Addendum No. 2

Project No.: 21046

Project: **Courtice Mixed Use Seniors Development at 1697 Highway # 2
RH GAY HOLDINGS COMPANY**

The following information supplements and/or supersedes the bid documents issued on September 10 2024

**DRAWING:
THIRD & FOURTH
FLOOR FRAMING PLANS**

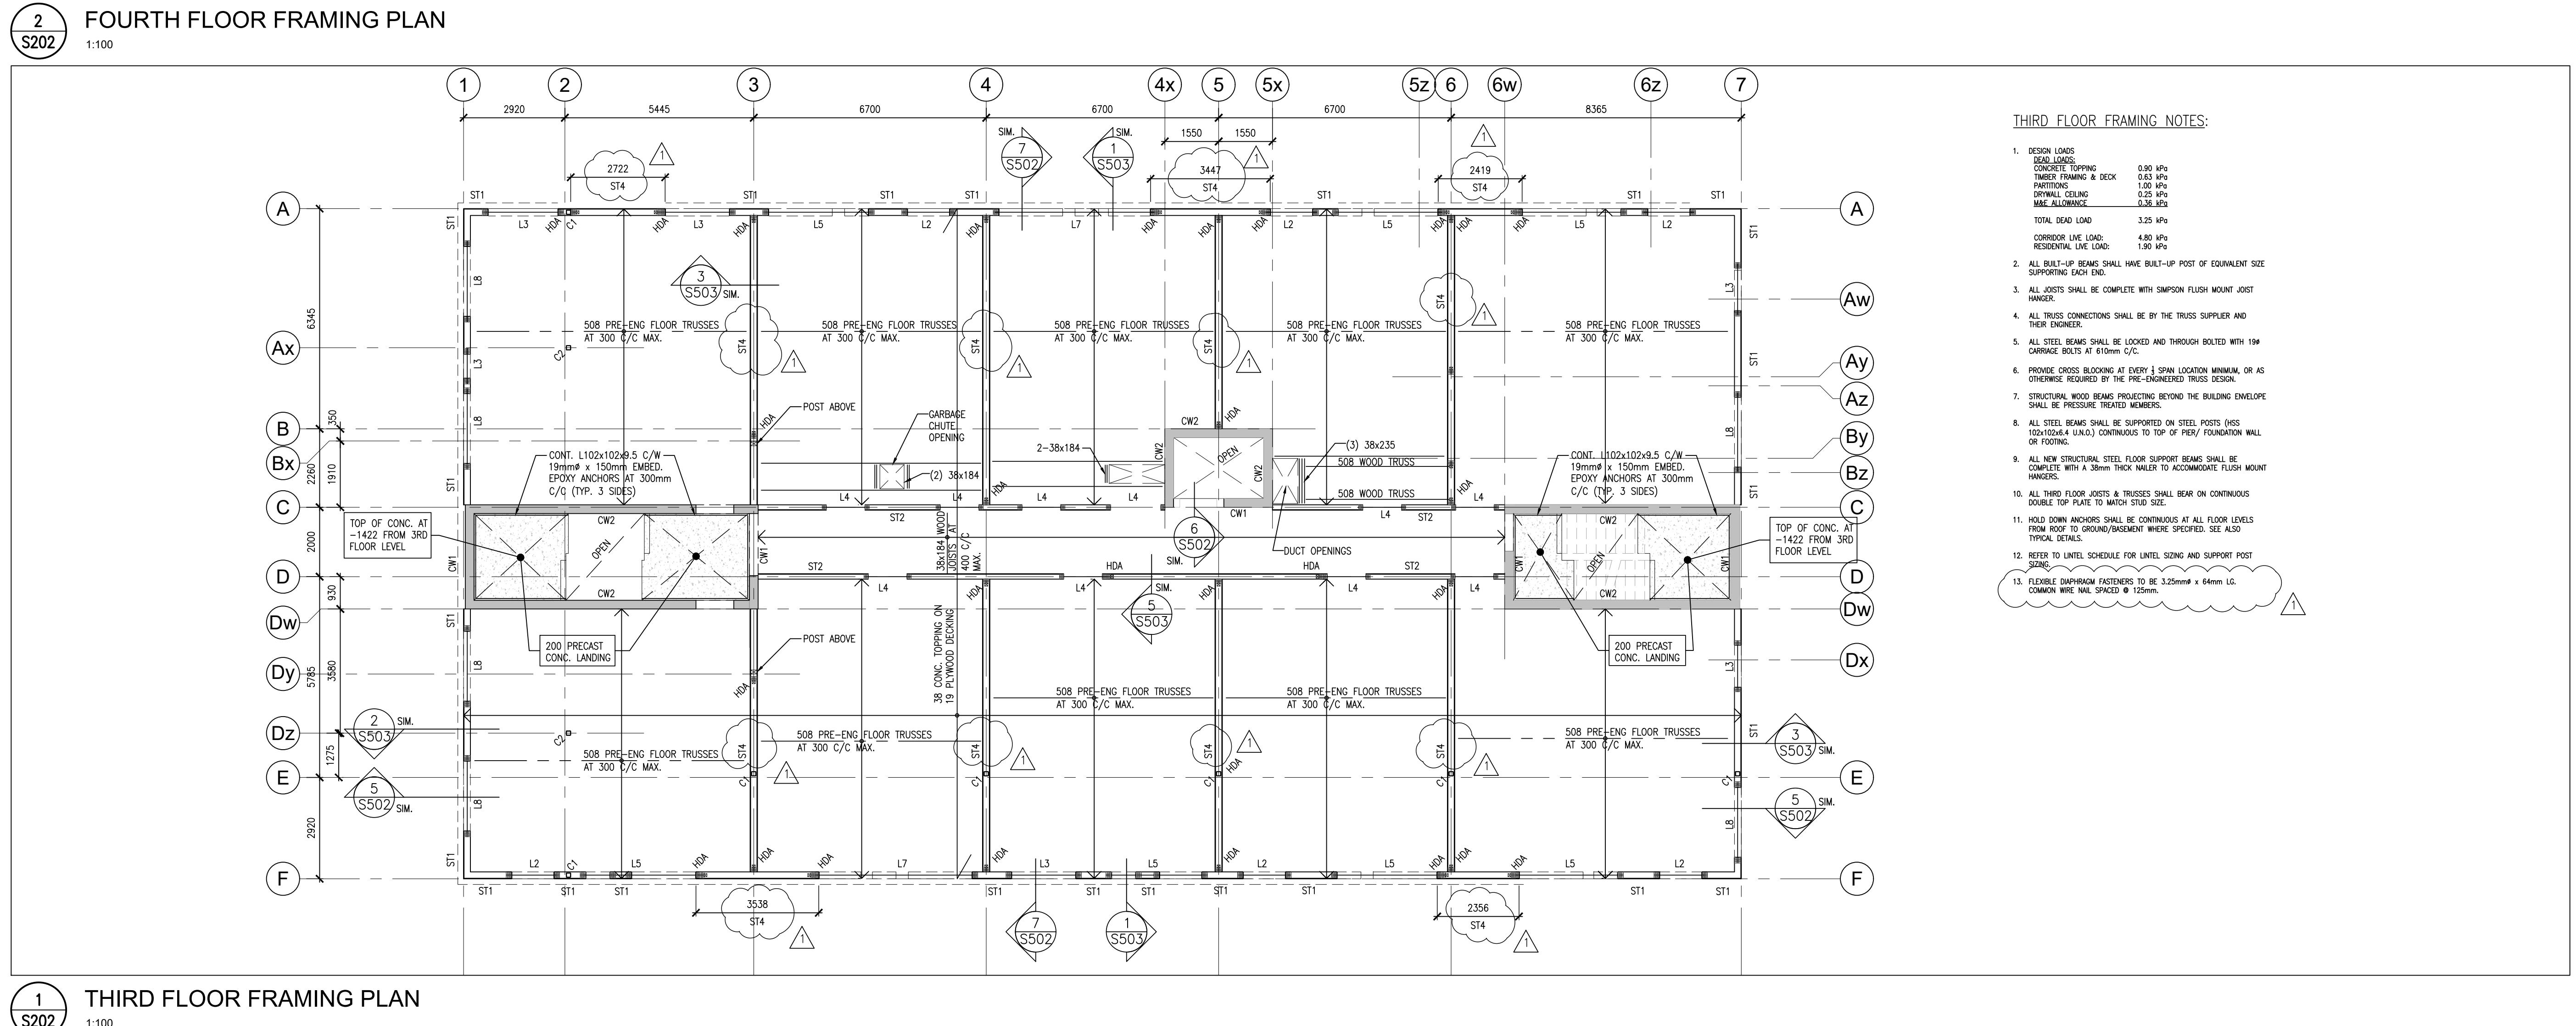
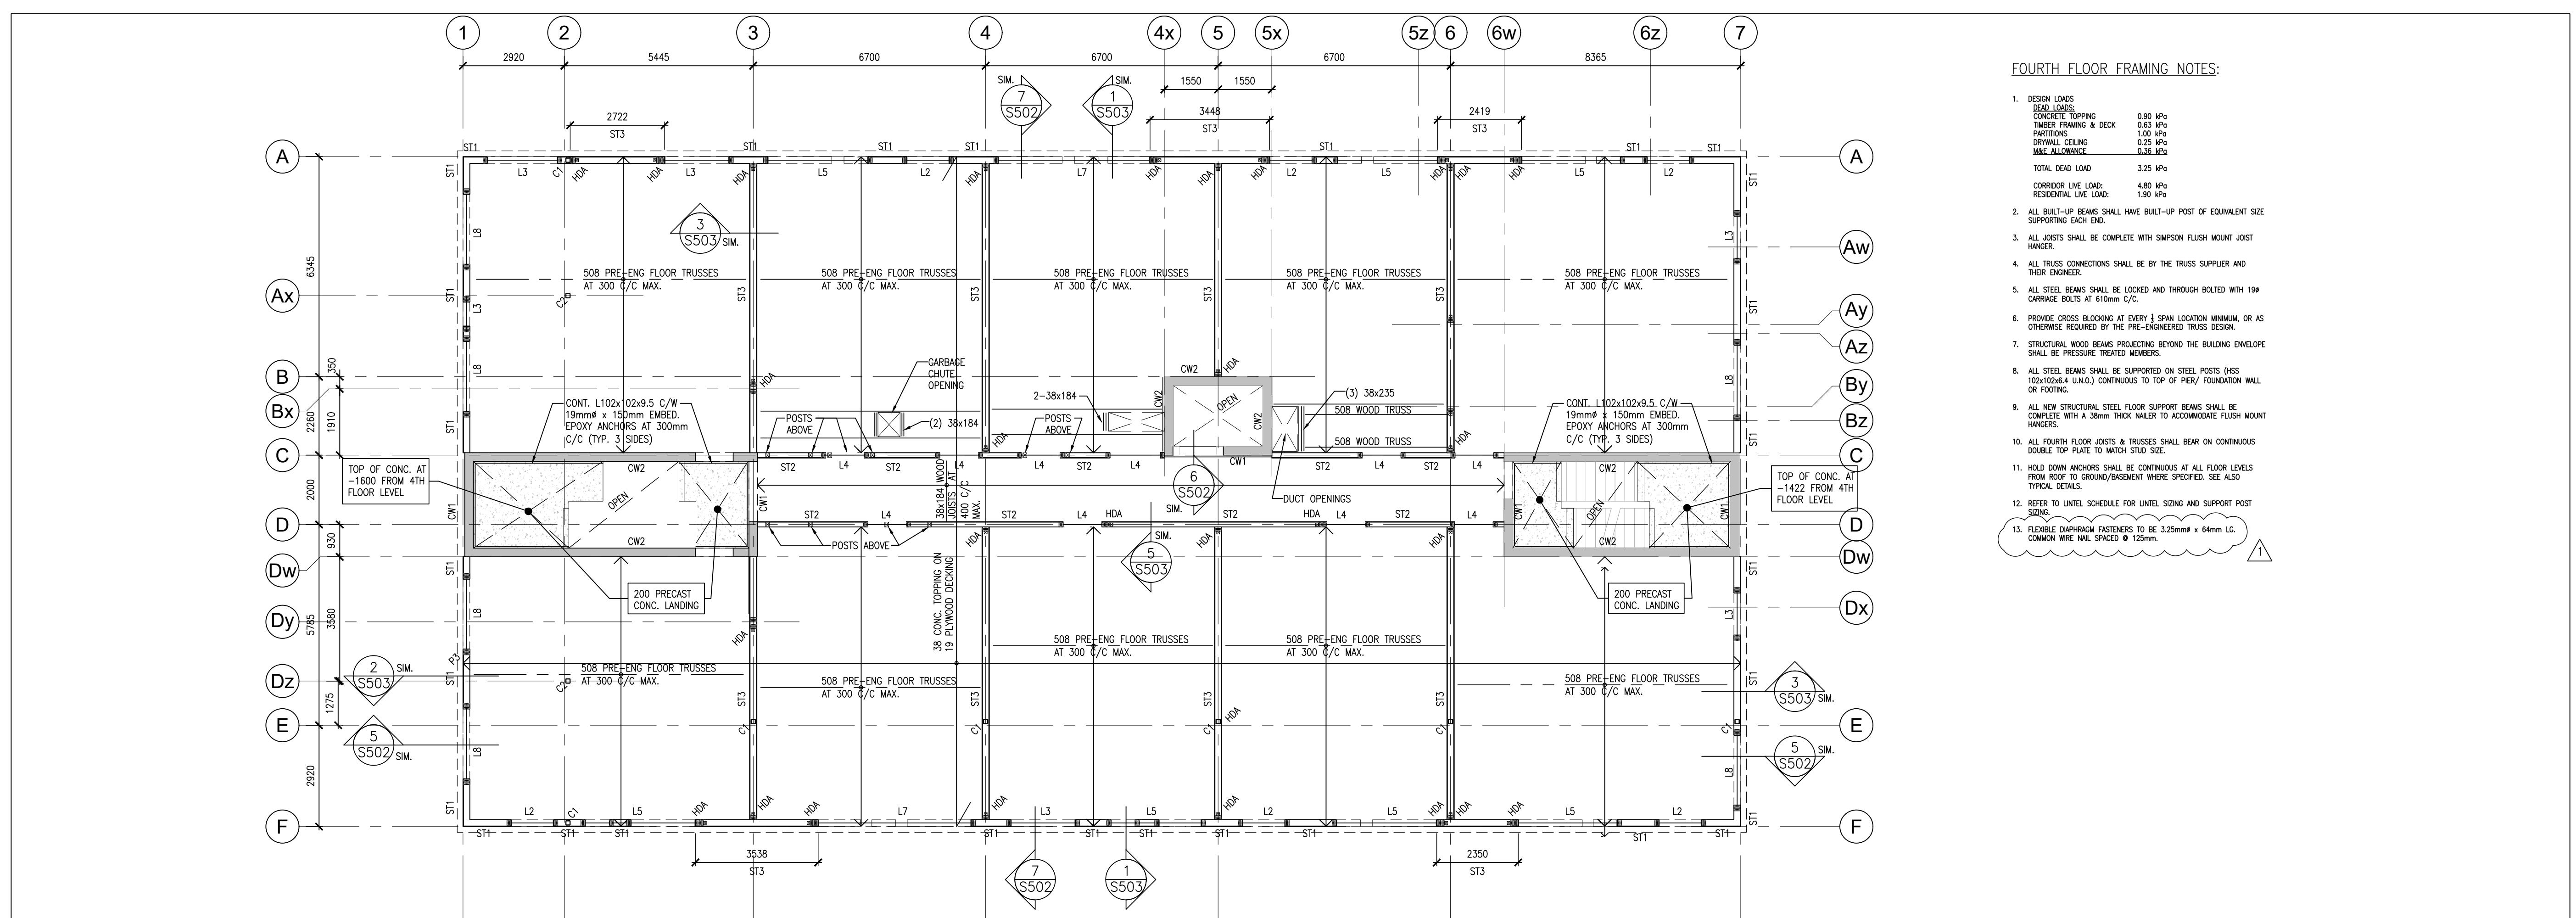
- .1 Shear wall 'ST4' tagged on 2/S202. Flexible diaphragm fasteners specified under Framing Notes on 1/S202 and 2/S202. Refer to BBA Drawing No. S202 dated September 3, 2024.

DRAWING:
FIFTH FLOOR & ROOF FRAMING PLANS

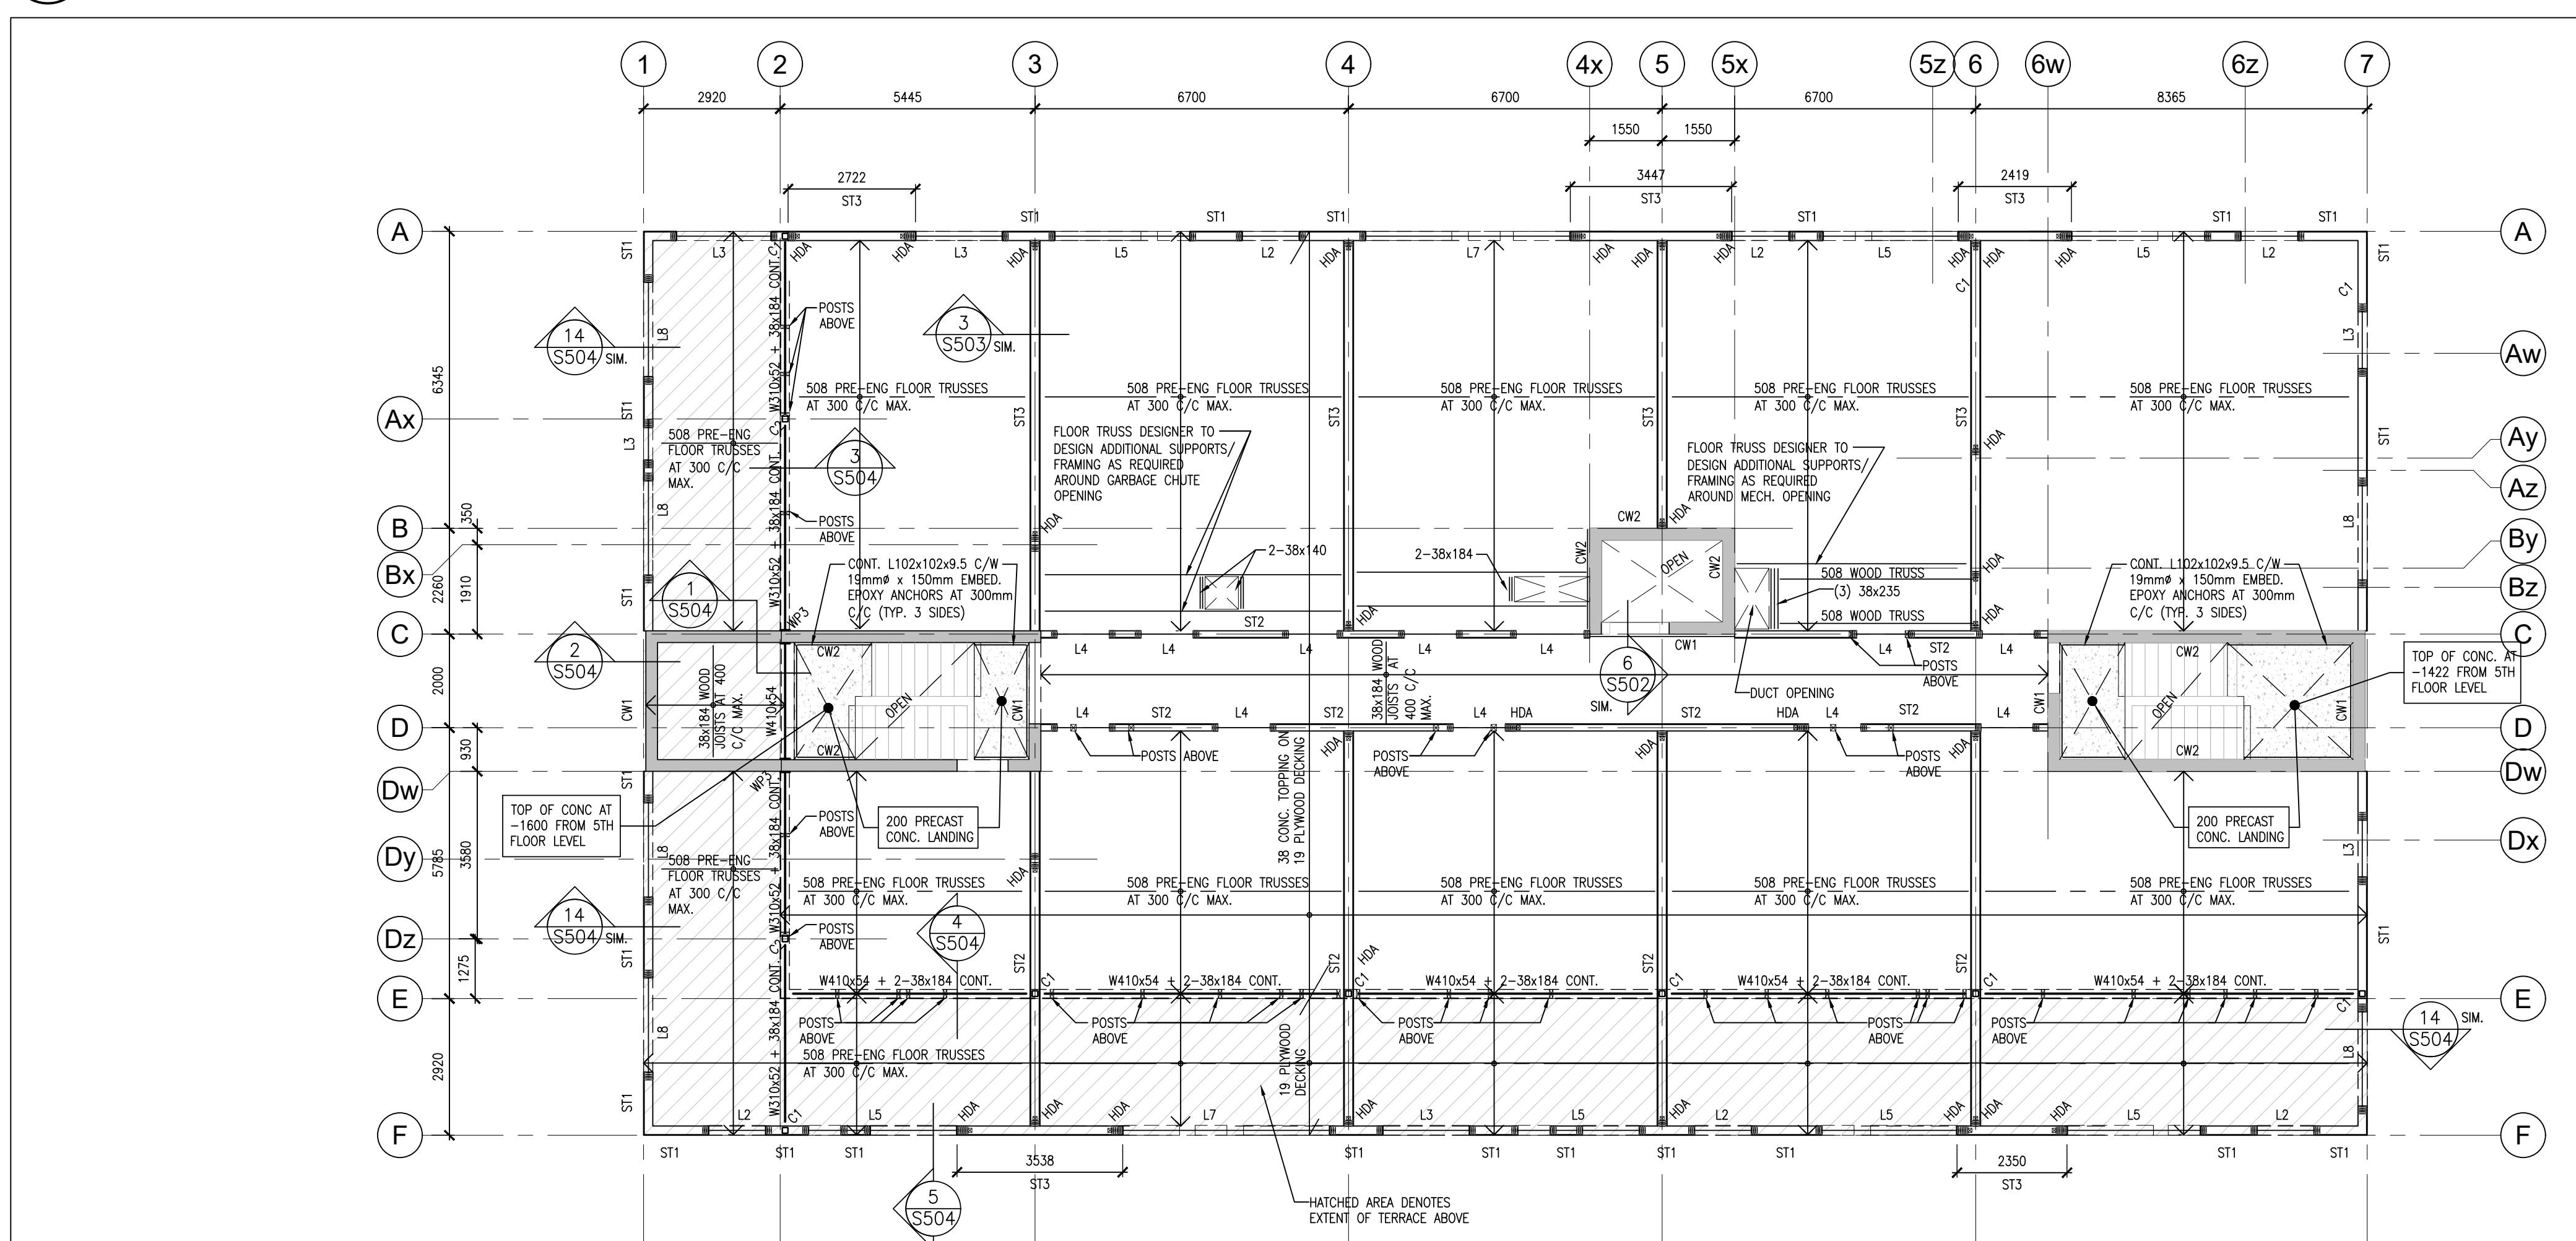
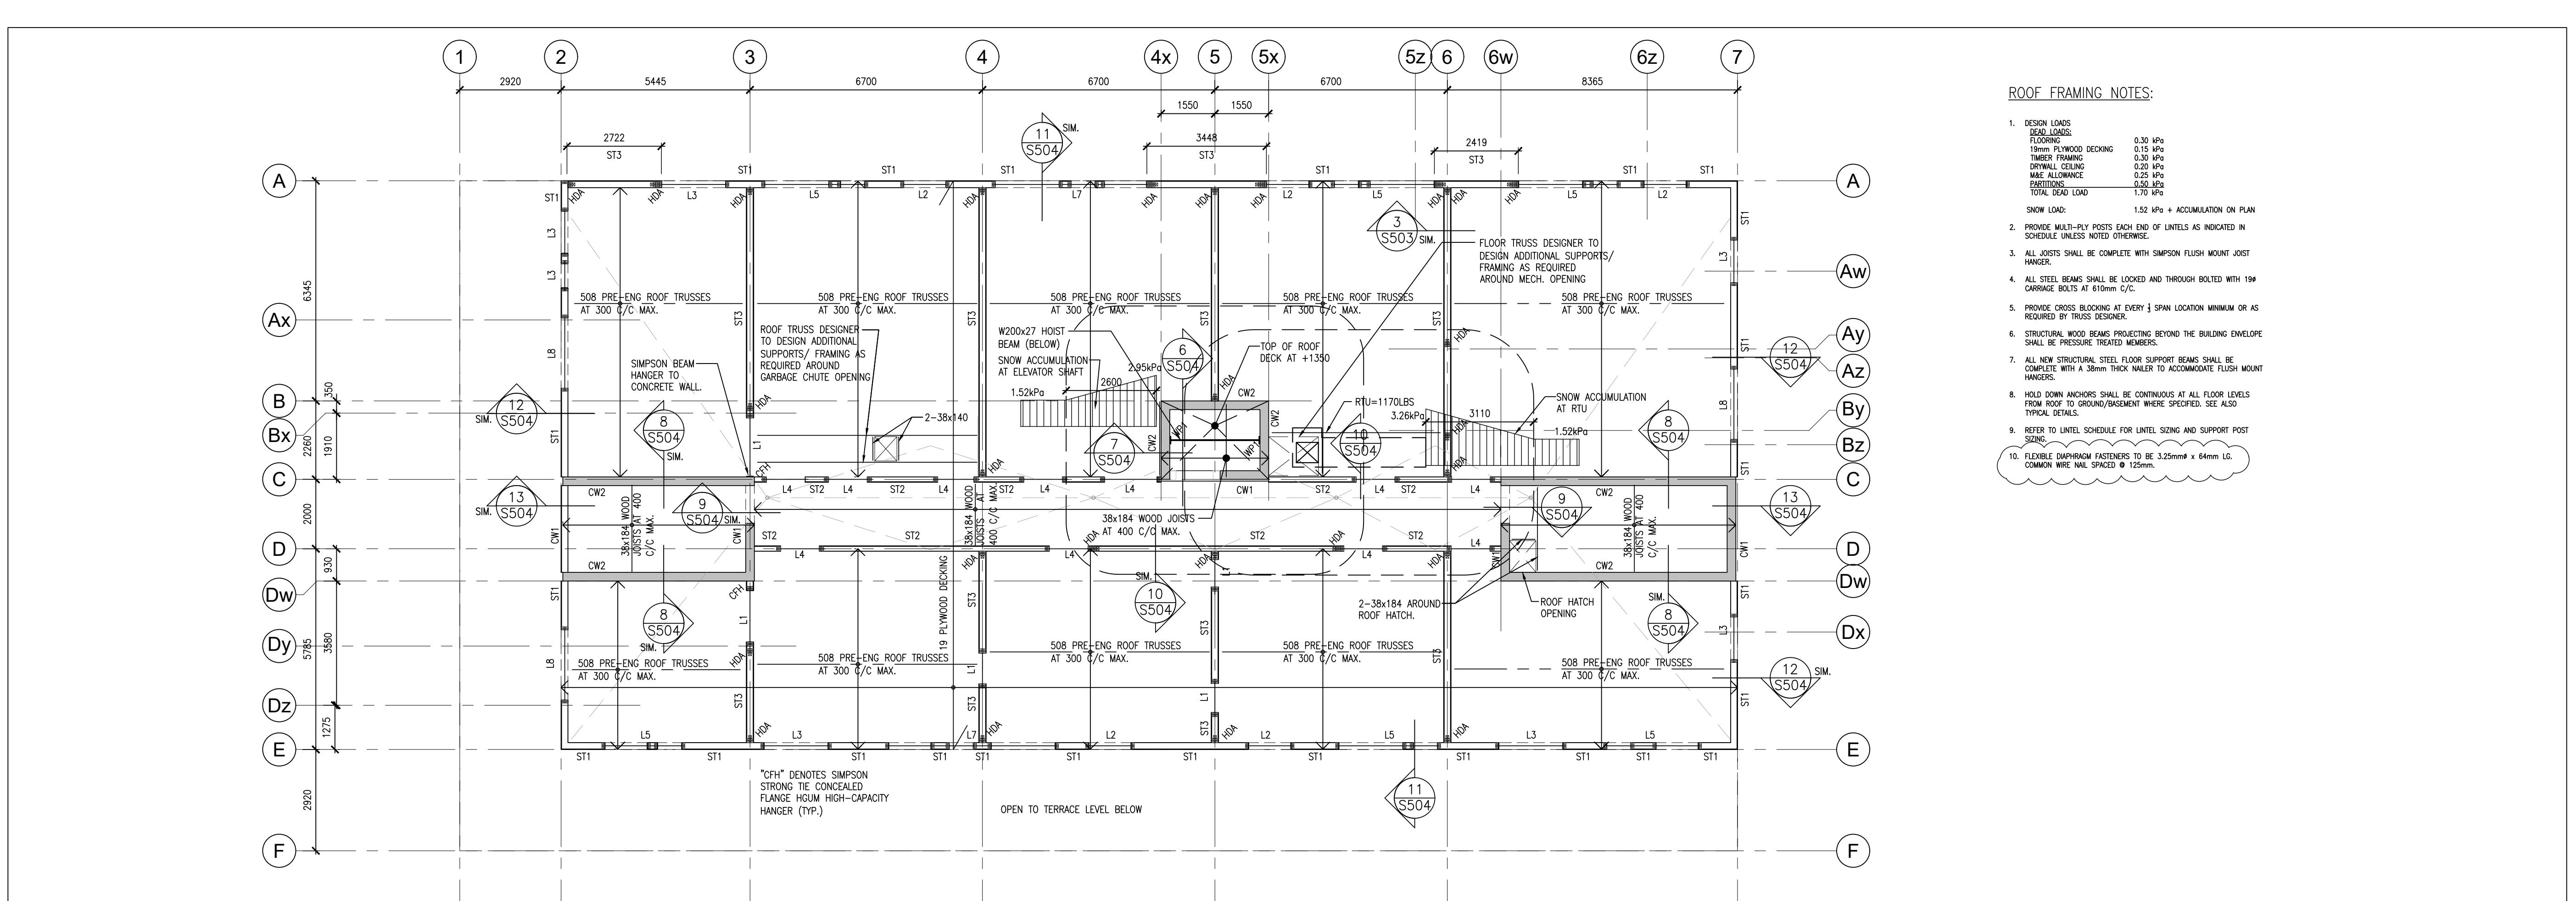
- .1 Flexible diaphragm fasteners specified under Framing Notes on 1/S203 and 2/S203. Refer to BBA Drawing No. S203 dated September 3, 2024.
